ARCHITECTURAL DRAWINGS

84 - 88 BIRRIGA ROAD
BELLEVUE HILL, NSW, 2023

PROPOSED NEW APARTMENT DEVELOPMENT OVER 2 BUILDINGS SET ON 2 ADJACENT LOTS,
INCLUDING 16 NEW APARTMENTS AND ASSOCIATED LANDSCAPING WORKS

2 DEVELOPMENT APPLICATION

1 BUILDING A : SOUTH ELEVATION
1:100

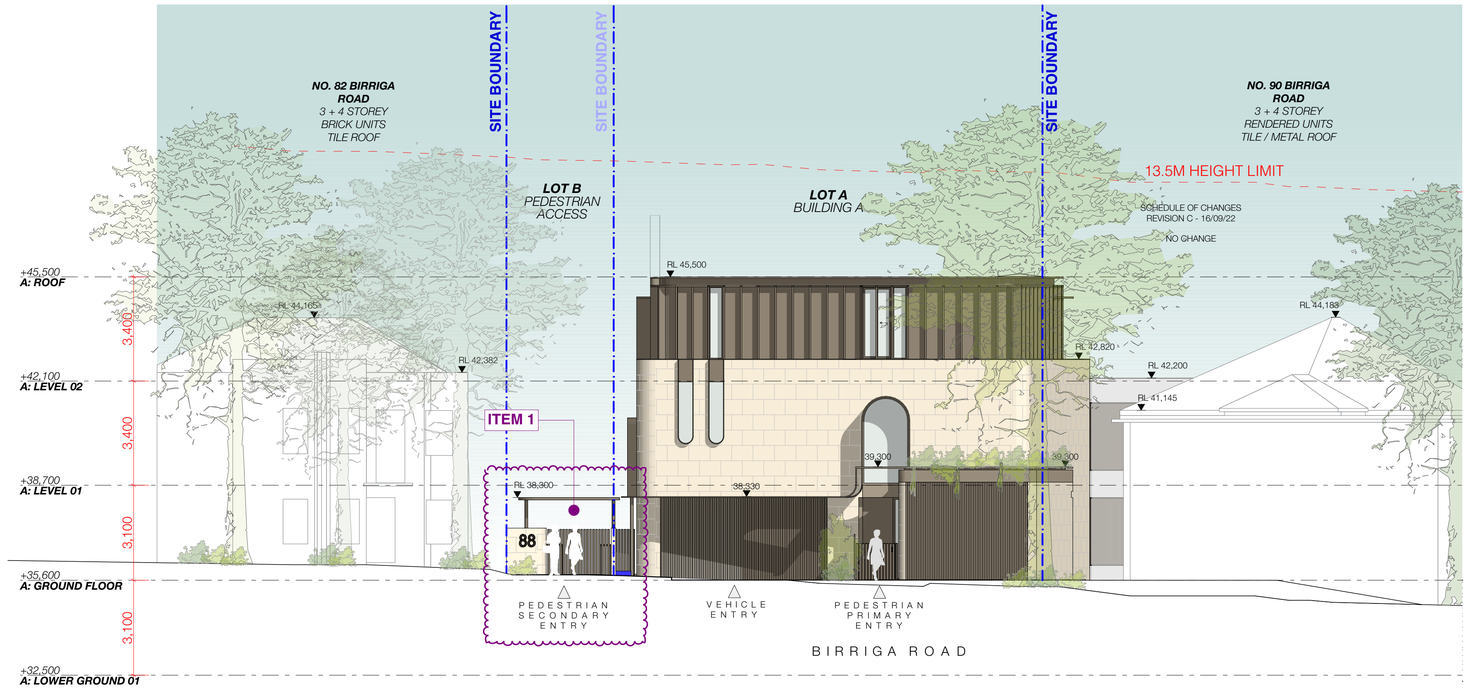
1. DETAIL OF PEDESTRIAN SECOND ENTRY, BOOSTER + GAS METER AMENDED. REFER TO PLANS.

1 BUILDING A : WEST ELEVATION
1:100

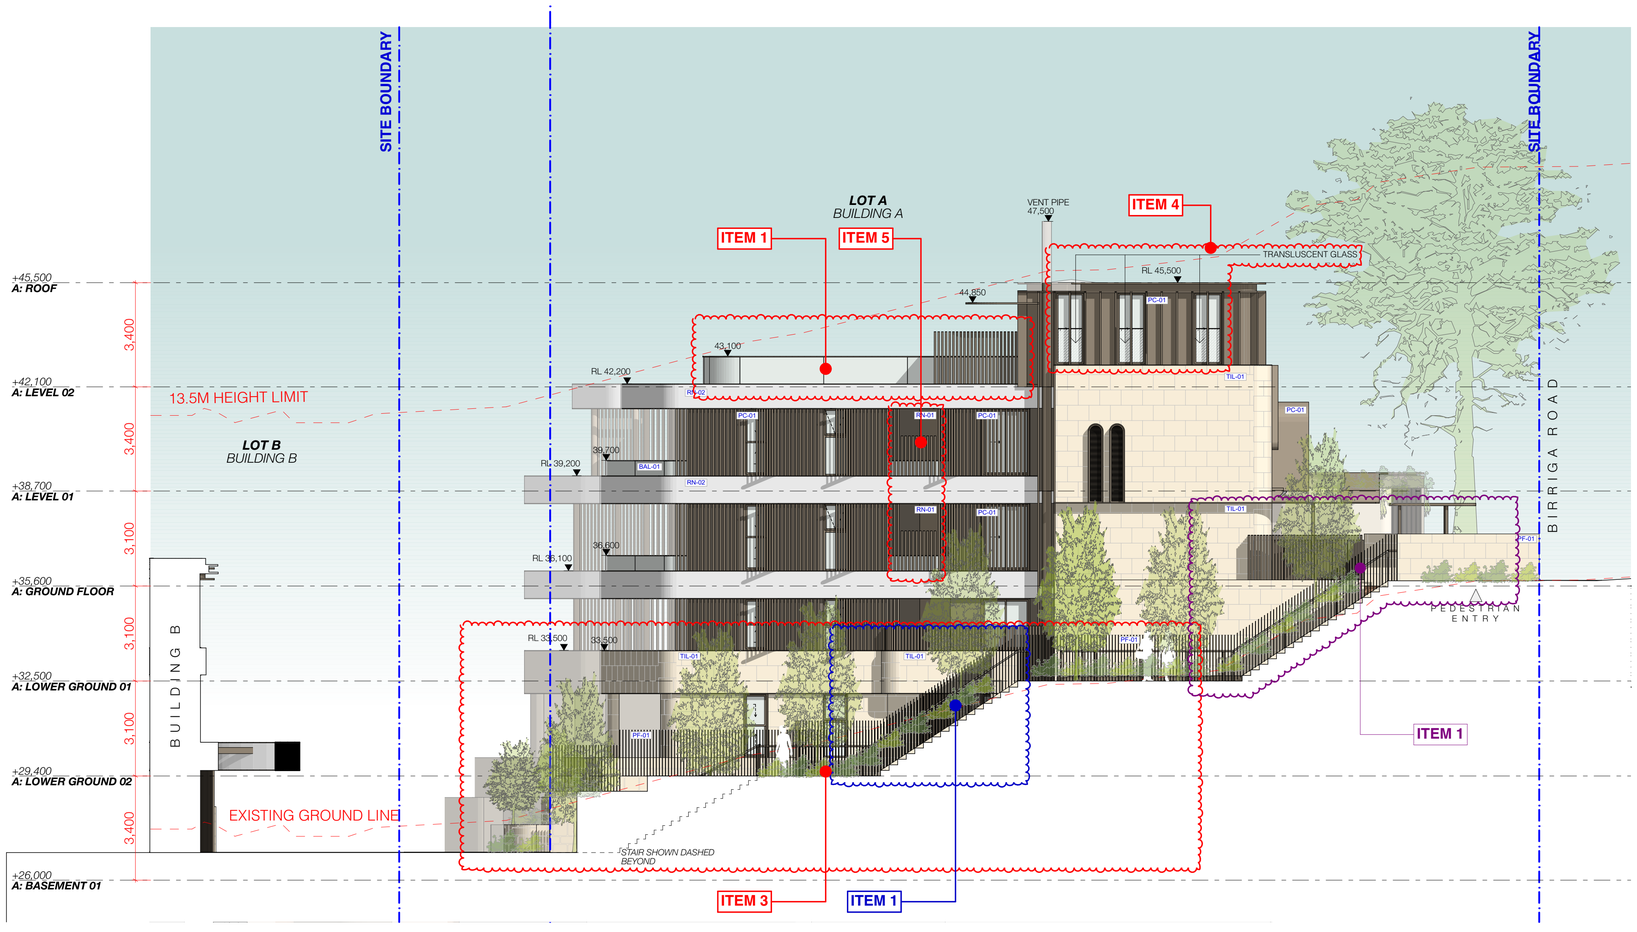
1. WESTERN STAIR SHIFTED FURTHER TOWARDS BIRRIGA ROAD. DETAIL OF PEDESTRIAN SECOND ENTRY, BOOSTER + GAS METER AMENDED ACCORDINGLY.

1 BUILDING B : EAST ELEVATION
1:100

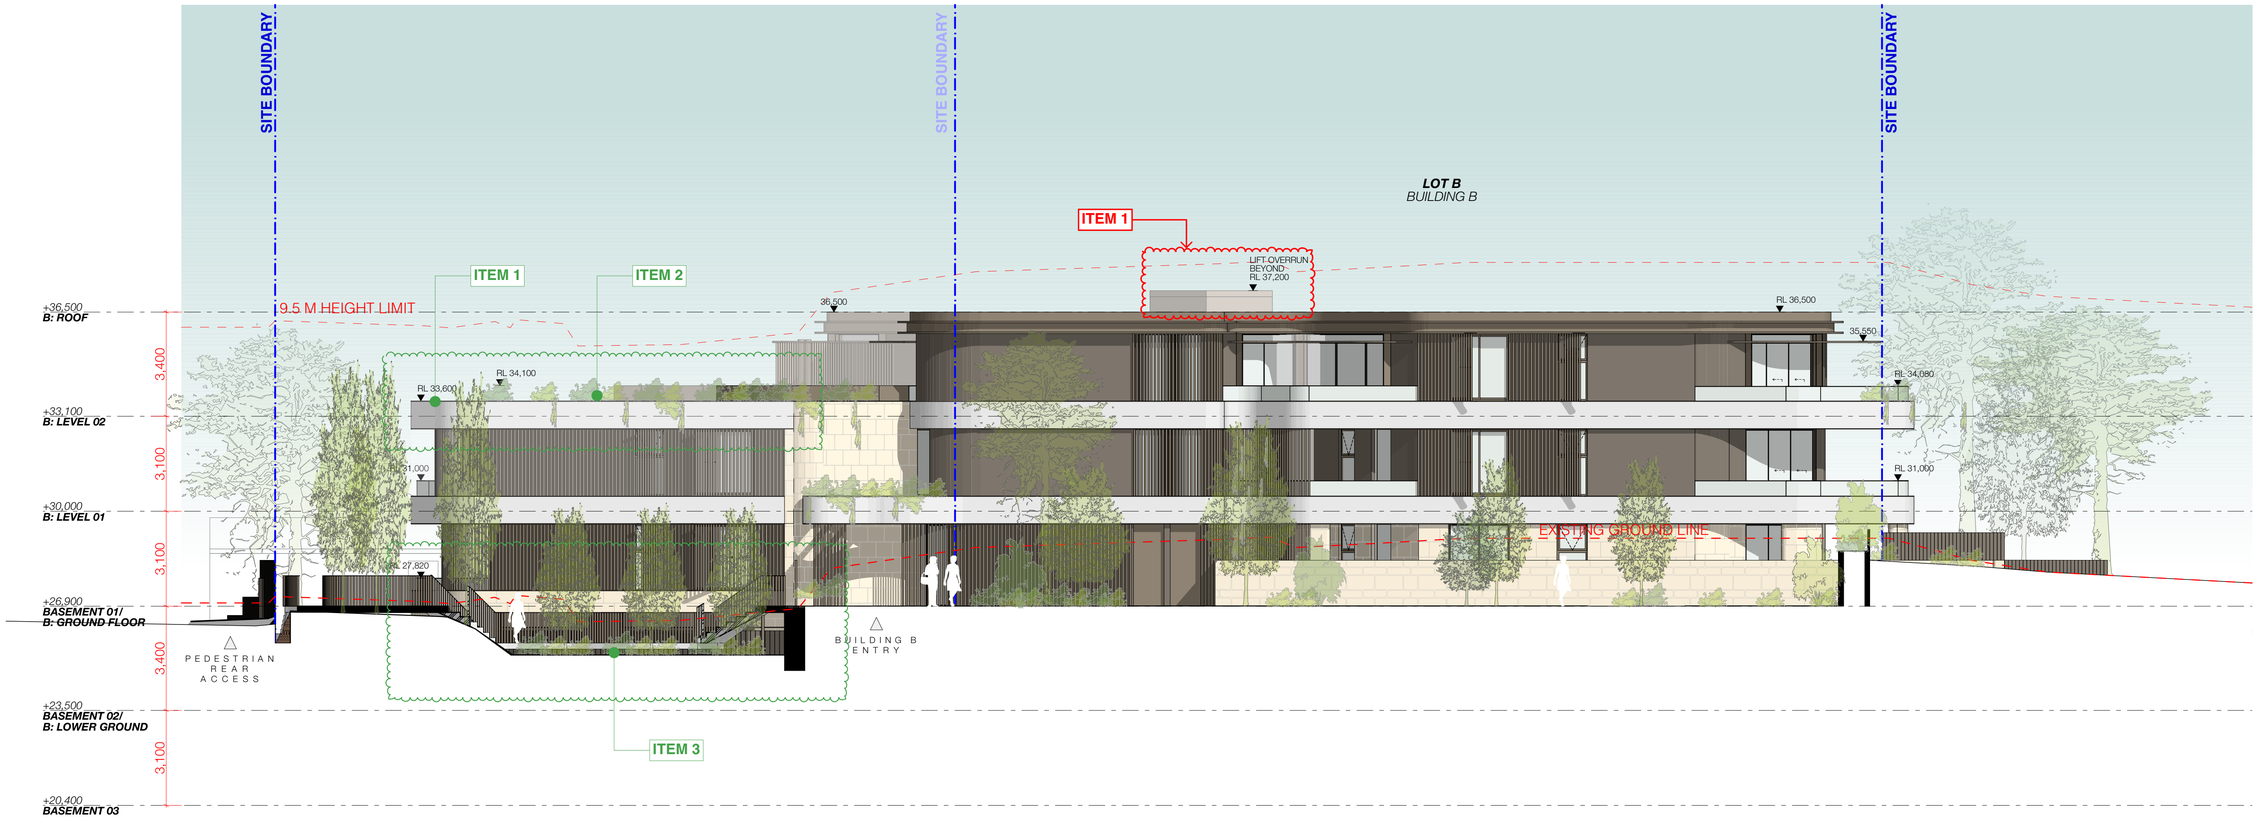
1. UPPER LEVEL (UNIT 301) FAÇADE MOVE BACK TO INCREASE BUILDING SEPARATION.
2. GREEN ROOF ADDED ADJACENT COMMUNAL ROOF TERRACE
3. EXTERNAL EGRESS WALKWAY AMENDED.

S-02 BUILDING A: SHORT SECTION
1:100

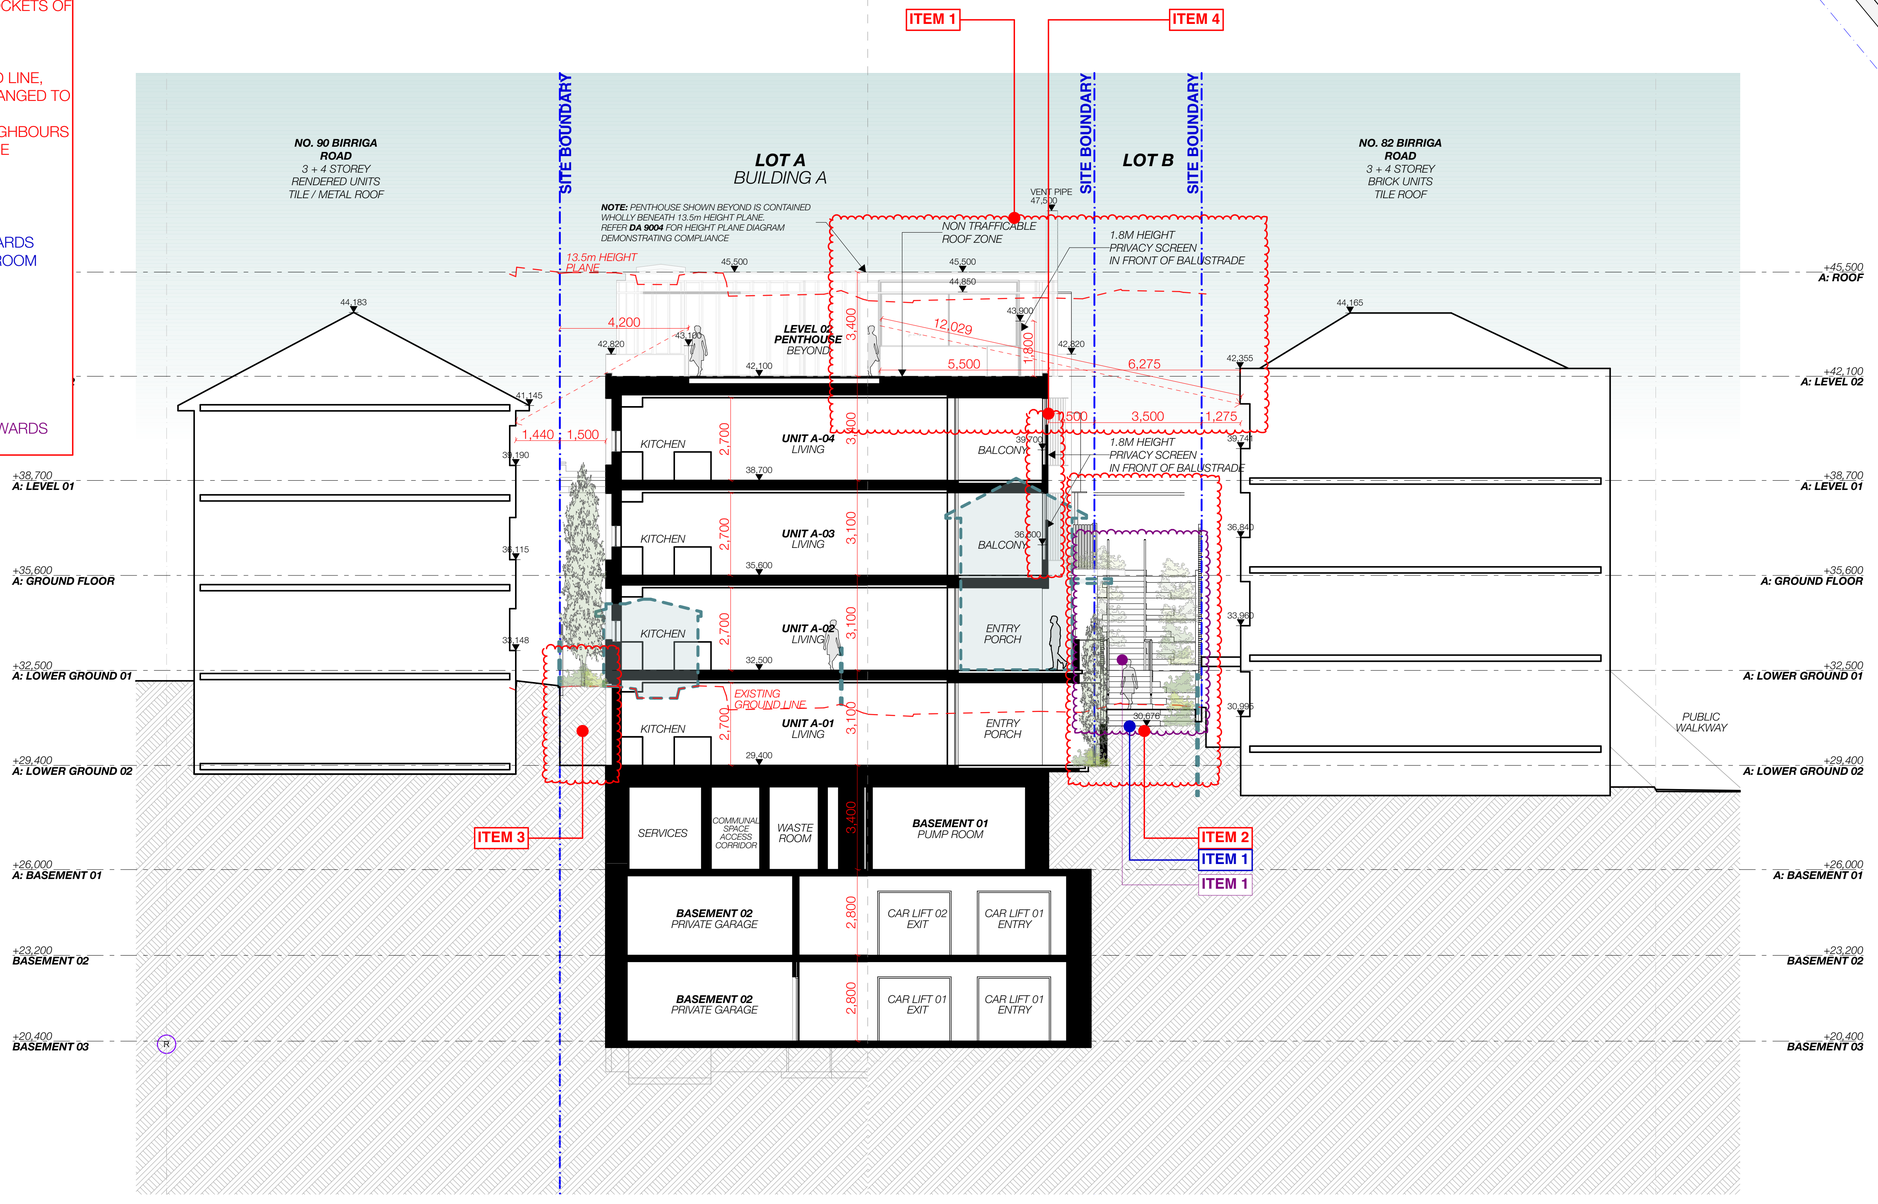
1. WESTERN STAIR SHIFTED FURTHER TOWARDS BIRRIGA ROAD.

S-03 BUILDING B: LONG SECTION
1:100

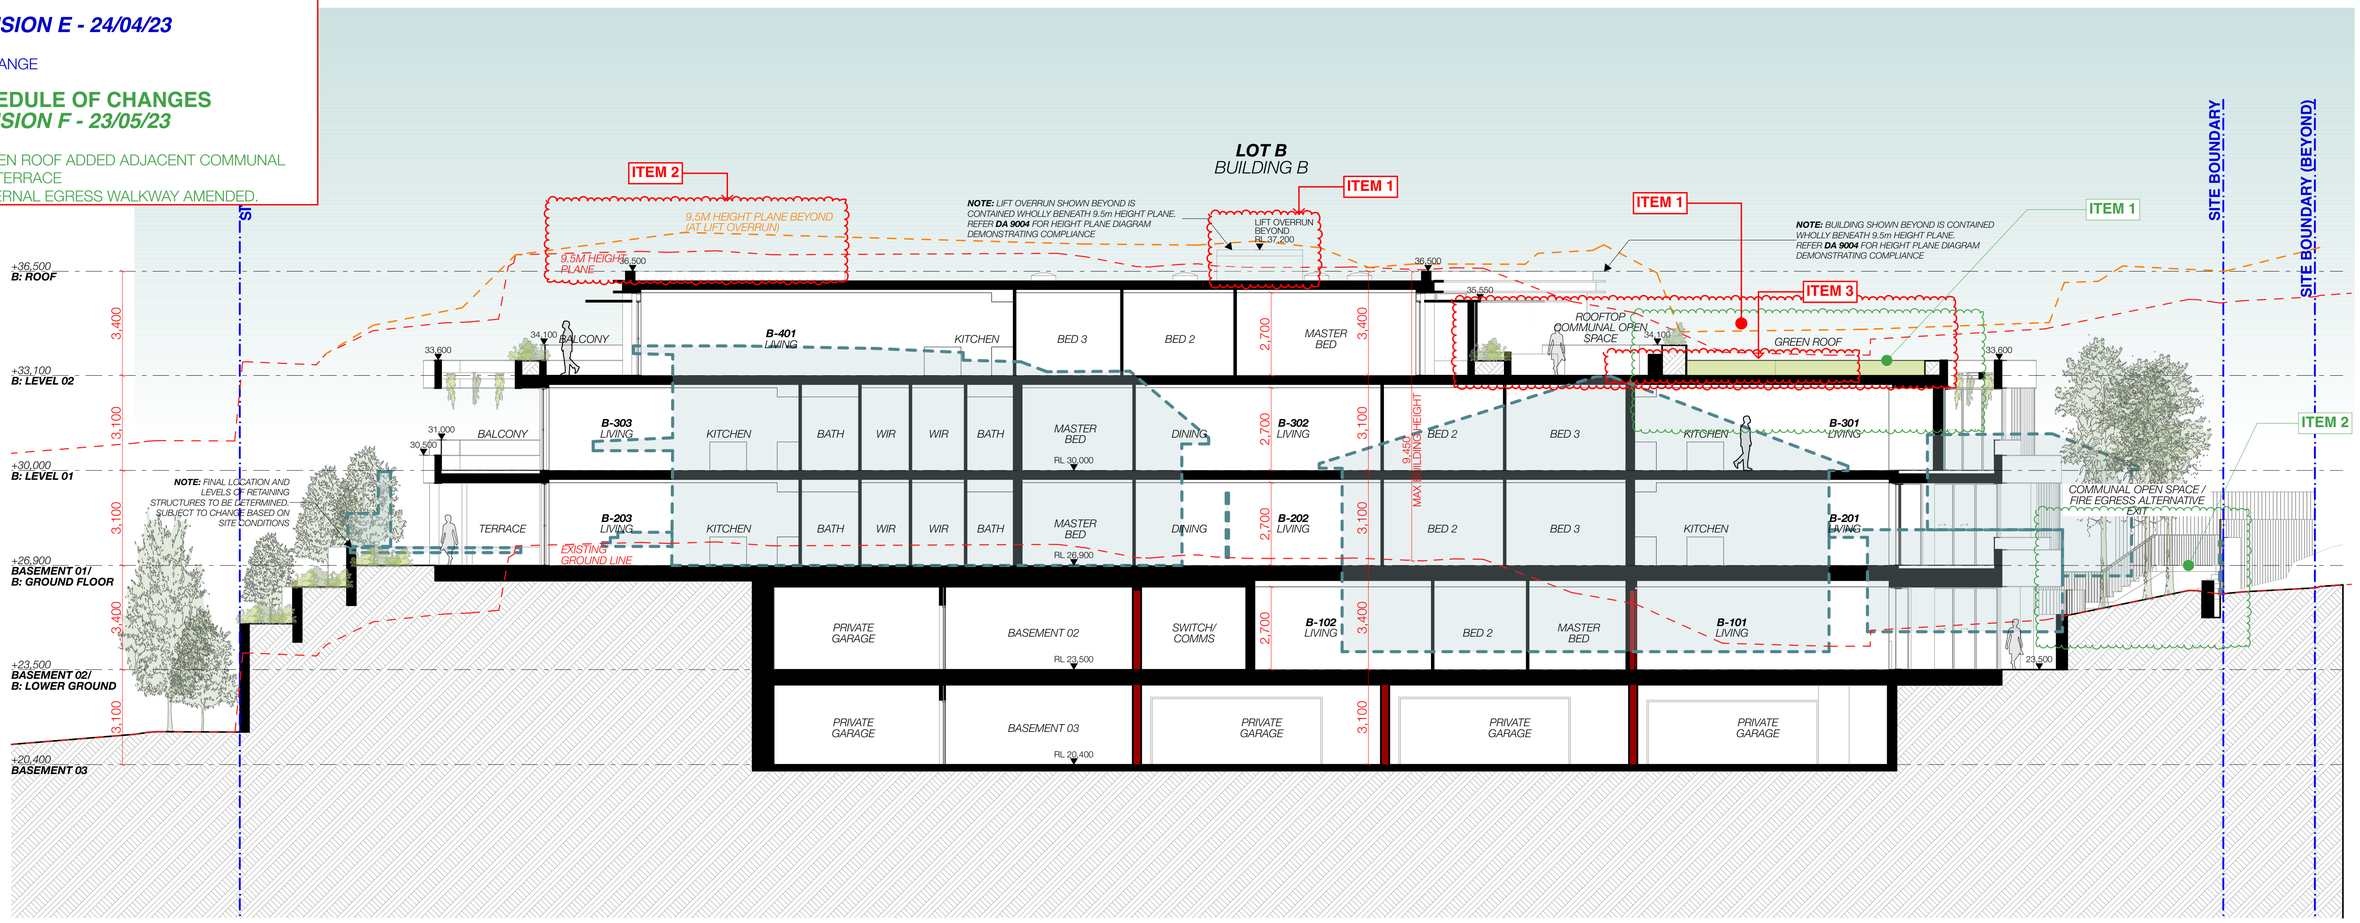
1. GREEN ROOF ADDED ADJACENT COMMUNAL ROOF TERRACE
2. EXTERNAL EGRESS WALKWAY AMENDED.

S-05 BUILDING B - BOUNDARY SECTION 01
1:100

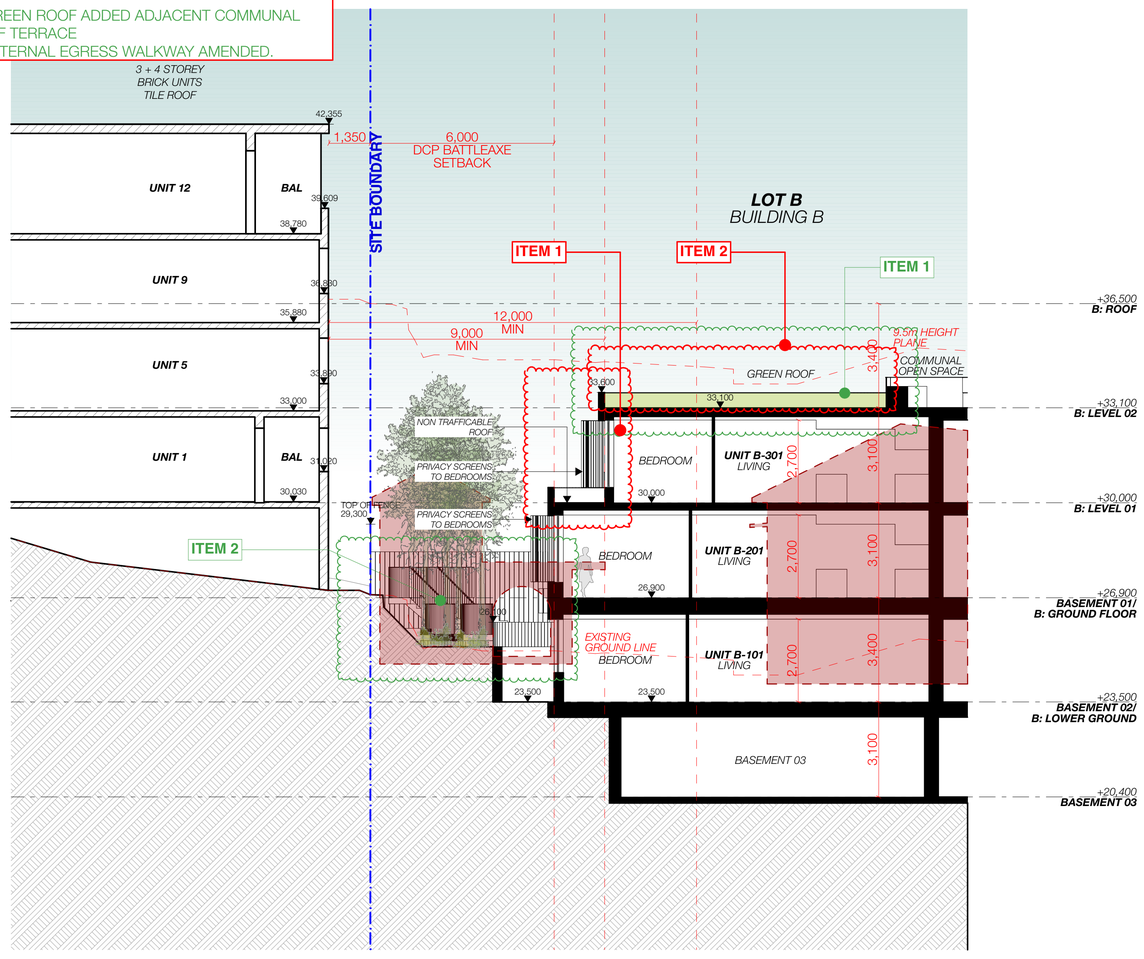
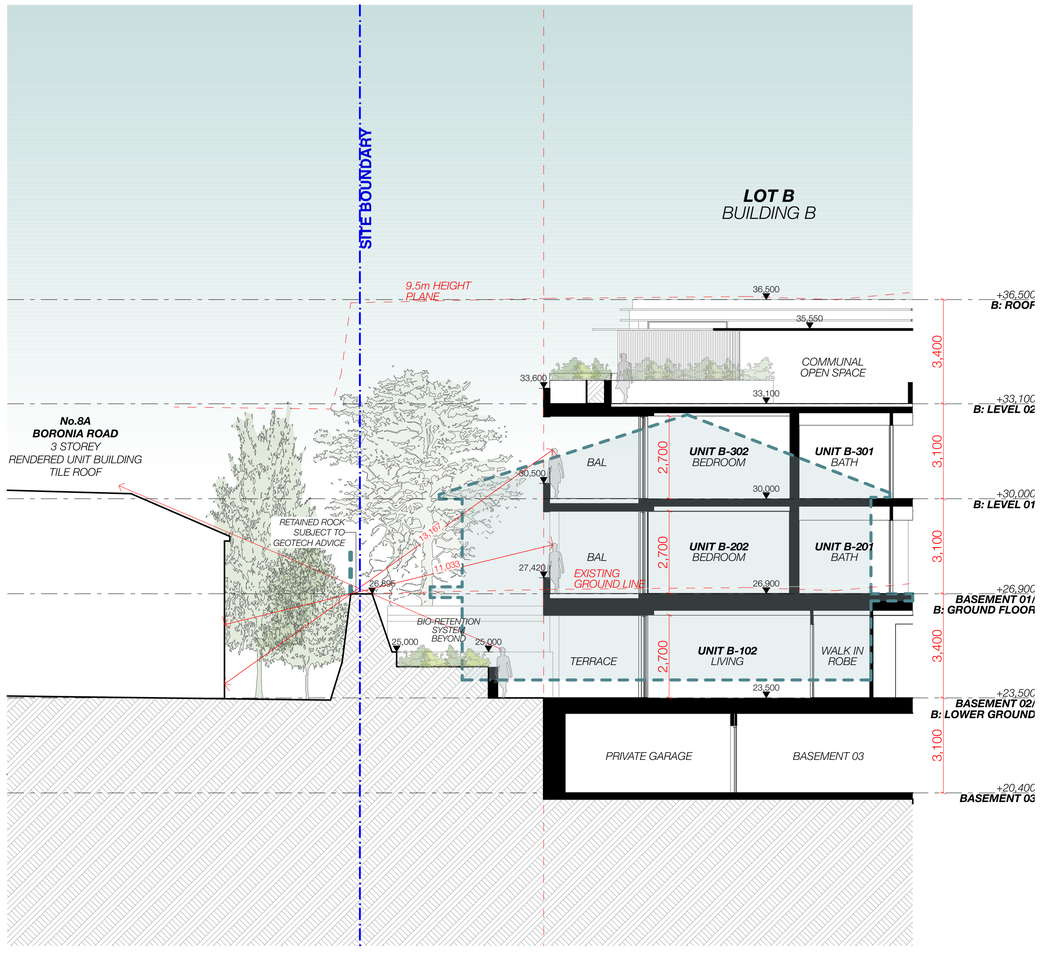
1. GREEN ROOF ADDED ADJACENT COMMUNAL ROOF TERRACE
2. EXTERNAL EGRESS WALKWAY AMENDED.
